Access Compliance Report

Public Rights-of-Way

(Curb Ramps)

Intersection ID: 45518	Main Street: COTTON_PRESS_RD	Cross Street: MEADOW_BOTTOM_RD	Location: W
ADA ID: FE619212613D	Ramp Type: PerpDiag	Initial Pass/Fail: Fail	Overall Compliance: No
Severity Score: 33.75			
Codes/Mitigation Info/Possible Solution		Field Measurements/Component Compliance

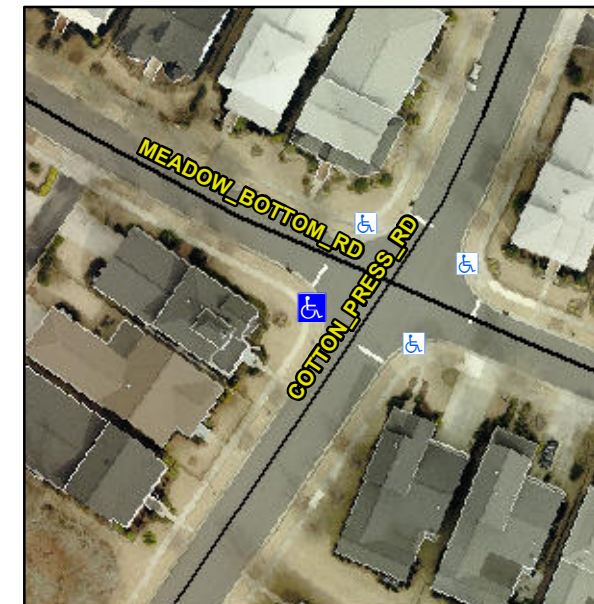
Not Found, R304.5.1, R304.2.2

Compliance	Description	Data	Compliance	Description	Data
N/A	Ramp Length (in)	72.0	No	Ramp Slope (%)	12.8
No	Ramp Width (in)	36.0	Yes	Ramp XSlope (%)	1.8
N/A	Flare Type LT	N/A	N/A	Flare Type RT	N/A
N/A	Flare Slope LT (%)	N/A	N/A	Flare Slope RT (%)	N/A
N/A	Flare Traversable LT?	N/A	N/A	Flare Traversable RT?	N/A
N/A	Landing Length (in)	N/A	N/A	DWS Provided?	N/A
N/A	Landing Width (in)	N/A	N/A	DWS Contrast?	N/A
N/A	Landing Slope (%)	N/A	N/A	DWS Length (in)	N/A
N/A	Landing X Slope (%)	N/A	N/A	DWS Full Width?	N/A
N/A	Landing Curb? (Y/N)	N/A	N/A	DWS Offset (in)	N/A
N/A	Shared Landing?	N/A			
N/A	Gutter Ponding?	N/A	N/A	Gutter Slope (%)	N/A
N/A	Gutter Lip Ht (in)	N/A	N/A	Gutter X Slope (%)	N/A
N/A	Painted X Walk1?	No	N/A	Painted X Walk2?	No
	X Walk 1 Direction	To SE		X Walk 2 Direction	To NE
N/A	X Walk 1 Width (in)	N/A	N/A	X Walk 2 Width (in)	N/A
	X Walk 1 Slope (%)	2.4		X Walk 2 Slope (%)	3.2
	X Walk 1 X Slope (%)	2.0		X Walk 2 X Slope (%)	0.8

Remove & Replace Curb Ramp With Two New Directional Ramps or Equivalent.
